Priority Projects Standing Advisory Committee Report

Referral No 7: Lot 6 Murray Valley Highway, Echuca

19 February 2021

Figure 4 Location and form of the acoustic barrier

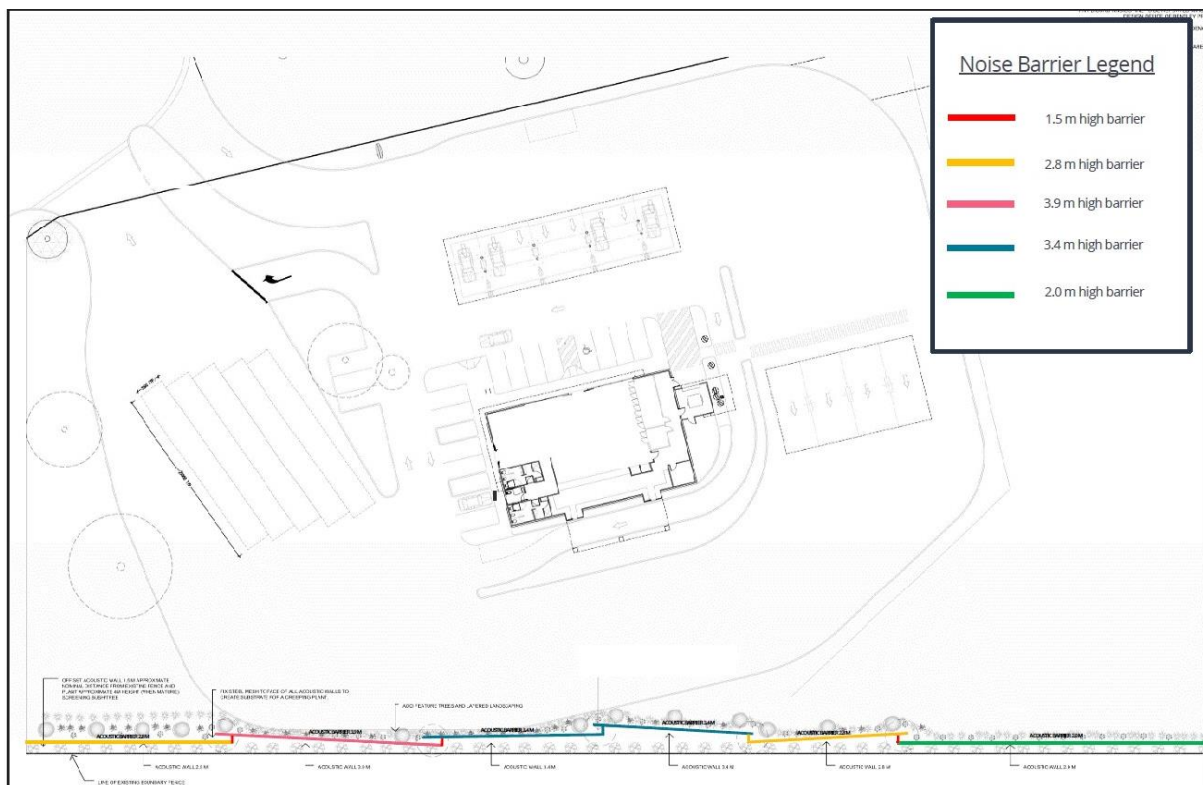
The acoustic barrier would be setback from the western boundary, as indicated in Figure 4 taken from the consultant report.

The submitted Landscape Plan (TP012) indicated that the 3.0 metre high peppermint willow trees planted along the gap between the acoustic barrier and the boundary fence are to soften the visual impact of the structure. The appearance of the landscape strip when viewed from the neighbouring properties will be crucial to achieving visual amenity along this part of the site. The objectors also had a concern relating to heat generated by the built form of the concrete block barrier that could apply to vegetation and people. The Landscape Plan was relied upon by the proponent as an appropriate treatment within the setback area. The Committee notes the requirement in proposed condition 1 for a detailed landscaping plan and the more specific requirements of proposed condition 3. With the inclusion of the agreed new condition 1f) the Committee sees no need to change the directions for the Landscape Plan. However, the Committee urges the proponent to confirm the selected plants are capable of surviving in the setback area, and will grow to a height that presents well to the residential properties. The Committee identifies this as a matter to be scrutinised by Council as responsible authority when the Landscape Plan is submitted for approval.

The Committee accepts this goodwill gesture of the proponent. It was made in the spirit of the roundtable discussion. No recommendation is made to require the construction of the acoustic barrier before any other development may begin. However, in order to facilitate the bringing forward of the construction, should that be possible with the early supply of materials, the Committee adopts the circulated agreed proposed new condition. It provides that before the development starts, detailed acoustic plans and elevations (in accordance with the Acoustic Report prepared by Clarity Acoustics, Report R01 Rev1 1901, 3 October 2019) must be submitted and approved by the responsible authority.

f) Detailed plans including materials, location, height and service / maintenance access arrangements of the acoustic barrier along the rear (western) boundary of the site in accordance with Condition 5. The plans must show all measures taken to prevent access by the general public into the space that will exist between the western boundary of the site and the acoustic barrier.

Before the development starts, detailed acoustic plans and elevations (in accordance with the Acoustic Report prepared by Clarity Acoustics, Report R01 Rev1 1901, 3 October 2019) but with the height of the barrier no less than 3.9 metres abutting the residences R2 to R6, must be submitted and approved by the Responsible Authority. The construction of the acoustic barrier must be completed prior to the commencement of the use, and thereafter be maintained through repairs and for appearance, including the removal of graffiti, to the satisfaction of the Responsible Authority.
